Access Compliance Report

Public Rights-of-Way

Intersection ID: 47227	Main Street: VALLEYDALE_RD	Cross Street: OAKSHIRE_CR	Location:	N
ADA ID: B7A6A31F7DE5	Ramp Type: PerpDiag	Initial Pass/Fail: Pass	Overall Compliance: No	Severity Score: 10

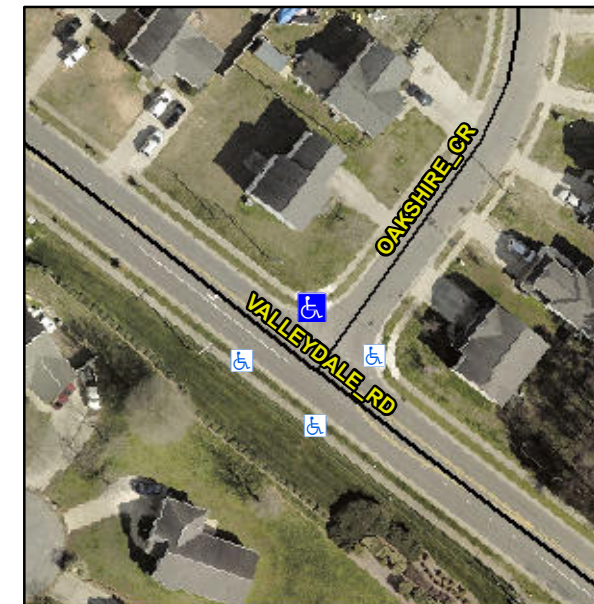
Not Found, R304.2.1, R304.5.3, R305

Compliance	Description	Data	Compliance	Description	Data
N/A	Ramp Length (in)	50.0	Yes	Ramp Slope (%)	7.5
Yes	Ramp Width (in)	52.5	Yes	Ramp XSlope (%)	0.7
N/A	Flare Type LT	Sloped	N/A	Flare Type RT	N/A
N/A	Flare Slope LT (%)	8.1	Yes	Flare Slope RT (%)	1.6
N/A	Flare Traversable LT?	Yes	N/A	Flare Traversable RT?	Yes
No	Landing Length (in)	44.0	No	DWS Provided?	No
Yes	Landing Width (in)	51.0	N/A	DWS Contrast?	No
Yes	Landing Slope (%)	0.9	N/A	DWS Length (in)	N/A
No	Landing X Slope (%)	2.6	N/A	DWS Full Width?	No
N/A	Landing Curb? (Y/N)	No	N/A	DWS Offset (in)	N/A
N/A	Shared Landing?	No			
Yes	Gutter Ponding?	No	Yes	Gutter Slope (%)	1.3
Yes	Gutter Lip Ht (in)	0.0	Yes	Gutter X Slope (%)	0.4
N/A	Painted X Walk1?	No	N/A	Painted X Walk2?	No
	X Walk 1 Direction	To SW		X Walk 2 Direction	To SE
N/A	X Walk 1 Width (in)	N/A	N/A	X Walk 2 Width (in)	N/A
	X Walk 1 Slope (%)	4.5		X Walk 2 Slope (%)	1.9
	X Walk 1 X Slope (%)	2.7		X Walk 2 X Slope (%)	3.4

Remove & Replace Curb Ramp With Two New Directional Ramps or Equivalent.
